JASPER JOHNSON SUBDIVISION

Engineering Comments: FINAL PLAT COMMENTS (should be addressed prior to submitting the FINAL PLAT for review and/or signature by the City Engineer):

APPLICATION NUMBER 6 DATE August 19, 2021
APPLICANT Jasper Johnson Subdivision
REQUEST Subdivision

DETAIL SITE PLAN

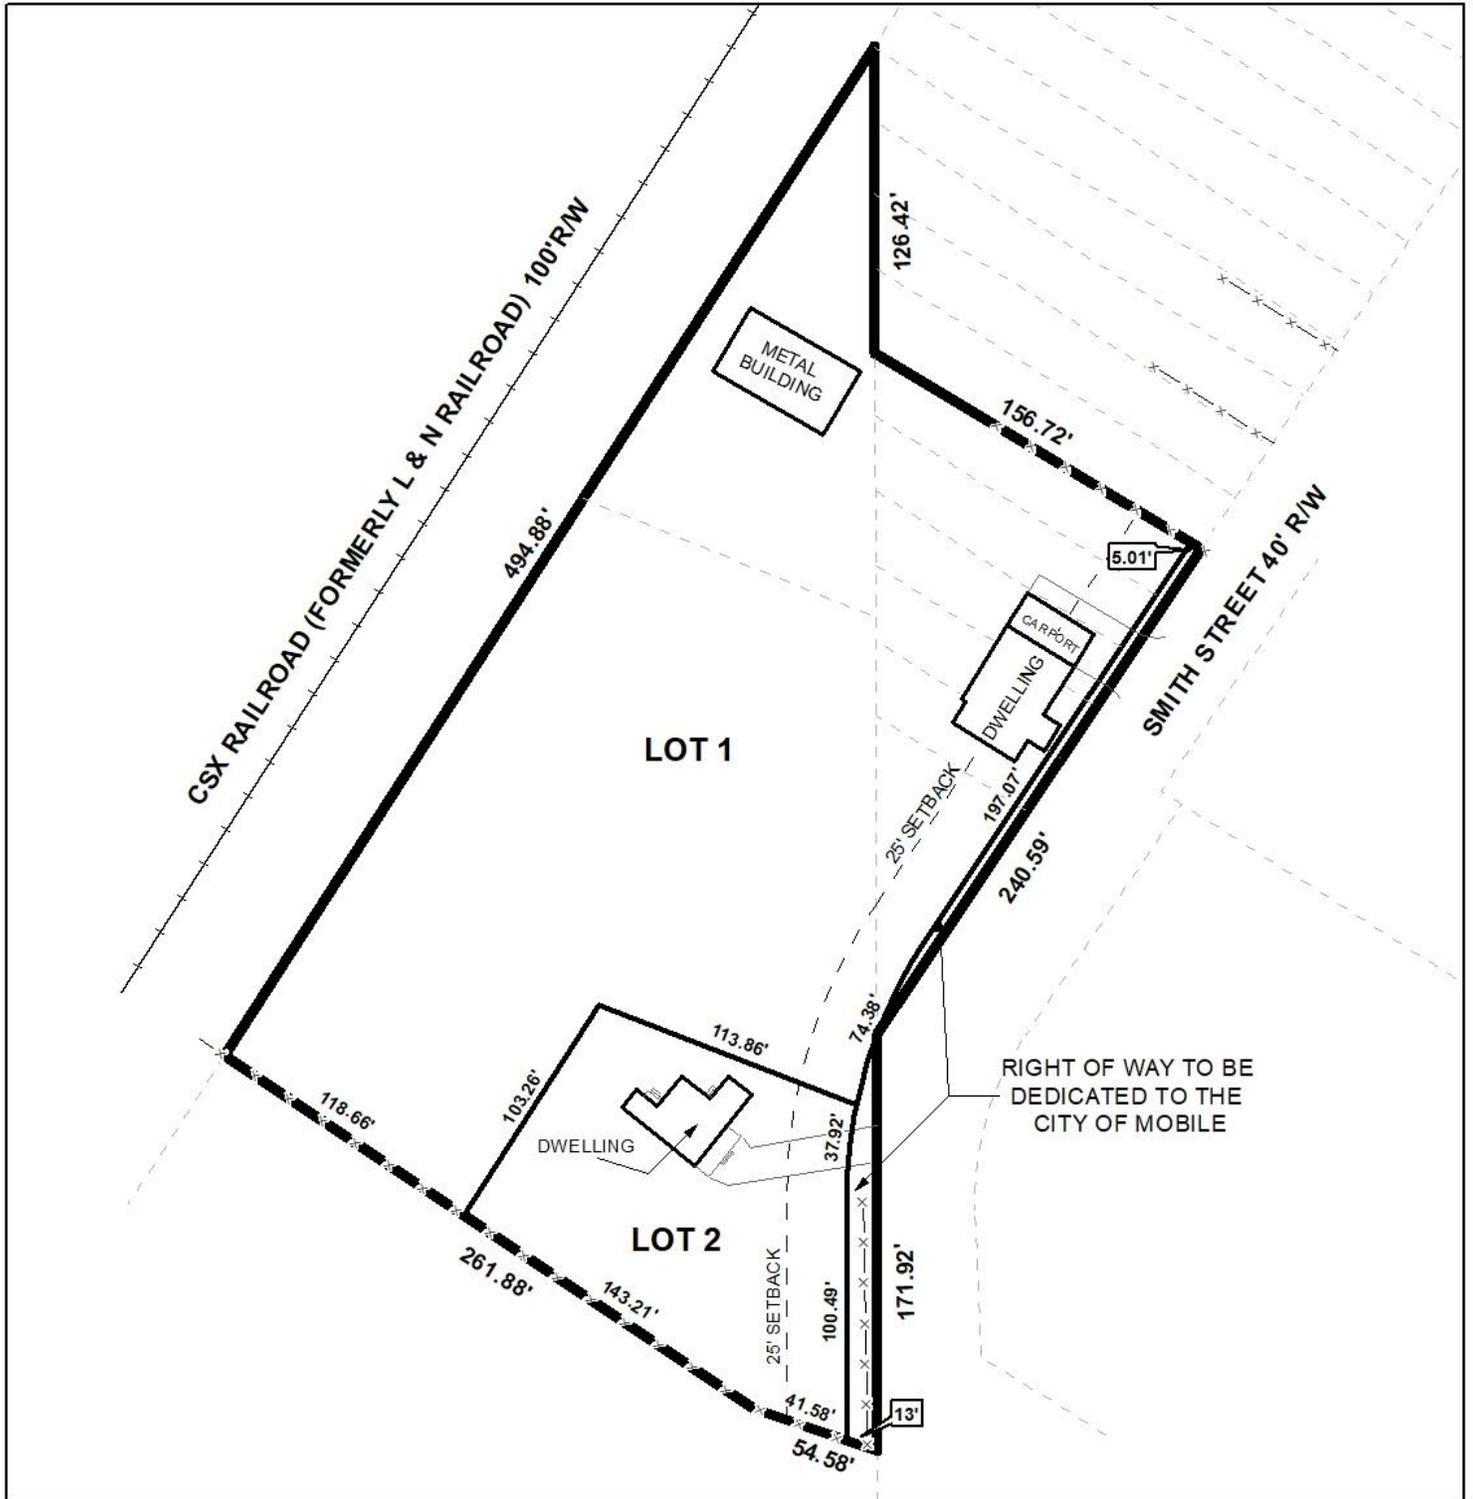
The site has frontage on Smith Street, a minor street with a non-compliant and variable right-of-way width and wing curb and gutter. Along the Northern end of the site, Smith Street has a current 40-foot right-of-way width. But along the front of the subject site, the right-of-way width never exceeds 25.9 feet from centerline, and appears to be approximately 12.5 feet from centerline toward the Southern end of the site. As Section V.B.14. of the Subdivision Regulations requires minor streets without curb and gutter to have a 60-foot right-of-way width, dedication to provide 30 feet from the centerline should be required. However, the applicant proposes dedication to provide 25 feet from the centerline along the site, with a 25-foot minimum building setback line beyond that.

As the dwelling near the Northern end of the site on proposed Lot 1 was developed to within approximately 7.5 feet from the current right-of-way line, a required dedication to provide 30 feet from the centerline would be impracticable, as would the requirement of a 25-foot minimum building setback line from the dedicated portion. Therefore, staff recommends a waiver of Section V.B.14. of the Subdivision Regulations for proposed Lot 1, with a requirement for dedication to provide 25 feet from the centerline along the frontage of Lot 1 as proposed. The 25-foot minimum building setback line along Lot 1 should be retained as indicated from the proposed dedication, with a note stating that the existing structure may remain, but any new construction must comply with the 25-foot minimum building setback.

Along the frontage of proposed Lot 2, there appears to be sufficient area to provide a dedication of 30 feet from the centerline of Smith Street, with a 25-foot minimum building setback line beyond, without encroachment into the dwelling area. Therefore, dedication should be required to provide 30 feet from the centerline of Smith Street, with a 25-foot minimum building setback line illustrated as measured from any required dedication.

The proposed lots meet the minimum size requirements of the Subdivision Regulations. As on the preliminary plat, the lot size labels in both square feet and acres should be retained on the Final Plat, as revised for any required dedication, or a table should be furnished on the Final Plat providing the same information.

- 1) dedication sufficient to provide 25 feet from the centerline of Smith Street along the front of Lot 1;
- 2) illustration of the 25-foot minimum building setback line along Lot 1 as measured from any required dedication, with a note stating that the existing structure may remain, but any new construction must comply with the 25-foot minimum building setback;

- 3) dedication sufficient to provide 30 feet from the centerline of Smith Street along the front of Lot 2;
- 4) illustration of a 25-foot minimum building setback line along the front of Lot 2 as measured from any required dedication;

- 5) retention of the lot size labels in both square feet and acres on the Final Plat, adjusted for any required dedication, or the furnishing of a table on the Final Plat providing the same information;
